TECHNICAL SERVICE BULLETIN

ITEM T81/13

SUBJECT: CYLINDER HEAD TORQUE P.D.I.

MODELS: TR7

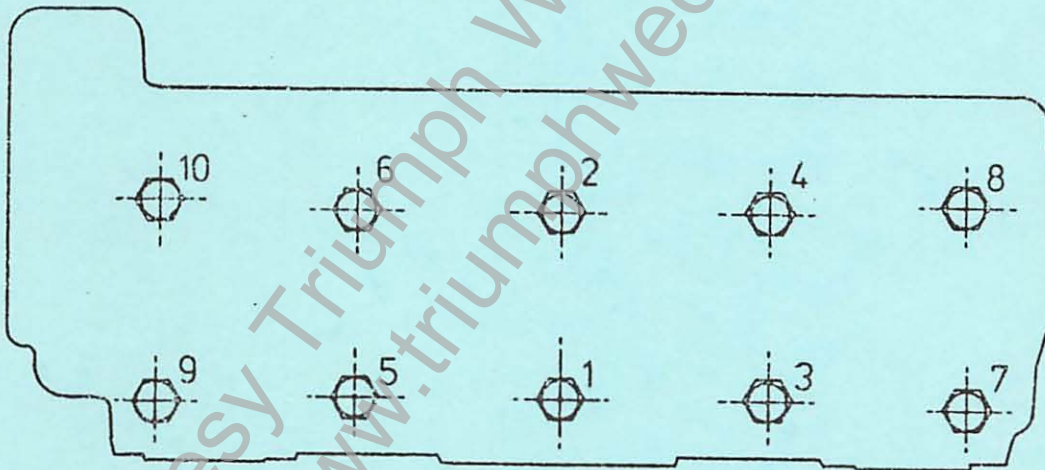
Present maintenance schedules call for torquing the cylinder head at 1,000 mile service. It is recommended by Triumph UK that this practice be discontinued and cylinder head torquing be done at P.D.I.

Upon receipt of this bulletin all dealer technicians should be made aware of the fact that before any P.D.I. work is started the cylinder head nuts and bolts must be torqued to 50 lb/ft with the engine COLD.

When checking the torque loading of nuts and bolts, they should first be slackened off to overcome static friction and retightened to the correct loading in the sequence illustrated.

When this has been done, a spot of paint should be applied to a head nut as a reminder that torquing is not necessary at the 1,000 mile service.
